BCA / NCC Building Code of Australia Compliance Report

**132 Wilbur Street,
Greenacre NSW 2190**

Issue - B 19/02/2024

SILVER END
PTY LTD

Figure 9.2.5b: External wall to Class 10a building with FRL (method 1)

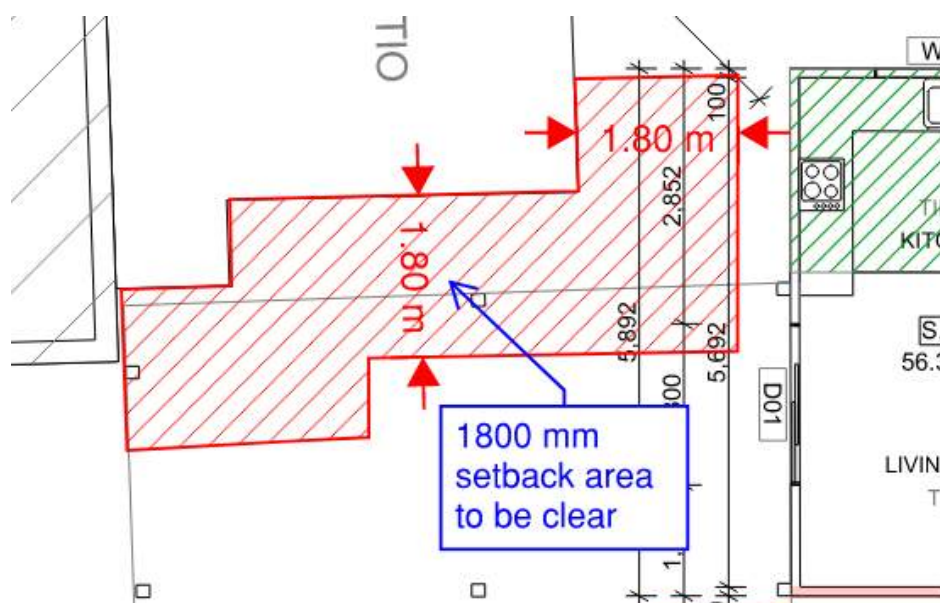
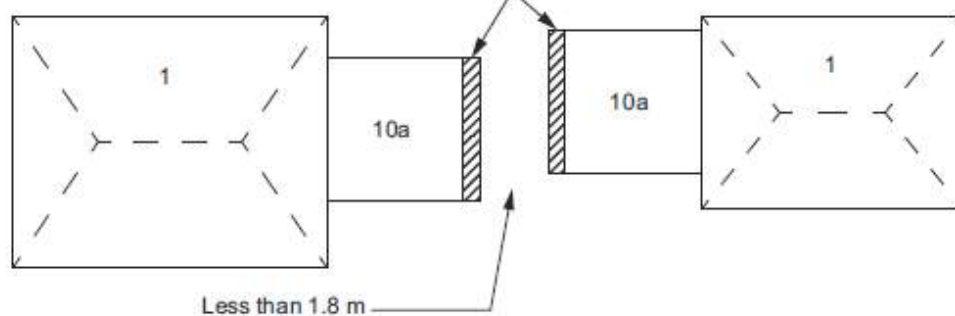
9.2.2	Measurement of distances	Noted	
9.2.3	Construction of external walls	Compliance	Construction of fire walls not required, as outlined in 9.2.1. Development in accordance with Figure 9.2.5d.
9.2.4	Class 10a buildings	Compliance	<p>9.2.4(1)(a) The Class 10a building is located between a Class 1 building and side a boundary. Proceed to clause 9.2.5 as required.</p> <p>A Class 1 building (Proposed Secondary Dwelling) must be protected by a method in 9.2.5 below, due to Class 10a attached verandah structure is located between or adjacent to a Class 1a building (Proposed</p>

<p>Secondary Dwelling) and the main principal dwelling, and a boundary alignment (Rear) that is not a boundary with a road alignment or other public space.</p> <p>This would facilitate the spread of heat fumes and smoke in the event of fire. It must be setback min. or 900 mm from side boundary and 1800 mm from the edge of the attached awning of the principal dwelling as noted on the marked-up plan.</p> <p>Blue board walls to be removed.</p>
<div data-bbox="252 840 1173 1818">  </div> <p>Blue board walls to be removed.</p>			
9.2.5	Protection of Class 1 buildings – Class 10a between Class 1 and	Non-Compliance	9.2.5(b) The Class 1 building is less than 900 mm from the Class 10a verandah structure in accordance with Figure

the allotment boundary		9.2.5d. Distance from boundary is < 900 mm. Adequate fire protection can be achieved by cutting back the carport roof as noted below.
--	------------------------	--	--

9.2.6	Protection of Class 1 buildings – Class 10a between Class 1 and other buildings on allotment	Non-Applicable	Refer to notes within clause 9.2.5
9.2.7	Protection of Class 1 buildings – separation of Class 10a buildings on an allotment	Non-Compliance	Refer to notes within clause 9.2.5 Class 10 a roof verandah and carport are less than 1.8m from each other within the same allotment. They need to be cut back.

9.2.8	Open carports	Non-Compliance	Refer to 9.2.5 and 9.2.7. Exemption of open carport does not apply as it is not open from 3 sides.
9.2.9	Allowable encroachments	Compliance	Encroachments of gutters and fascias are from non-combustible materials.
9.2.10	Roof lights	Non-Applicable	No roof lights.
Part 9.3 – Fire protection of separating walls and floors			Comments
9.3.1	Separating walls	Non-Applicable	No separating walls.
9.3.2	Services in separating walls	Non-Applicable	
9.3.3	Roof lights	Non-Applicable
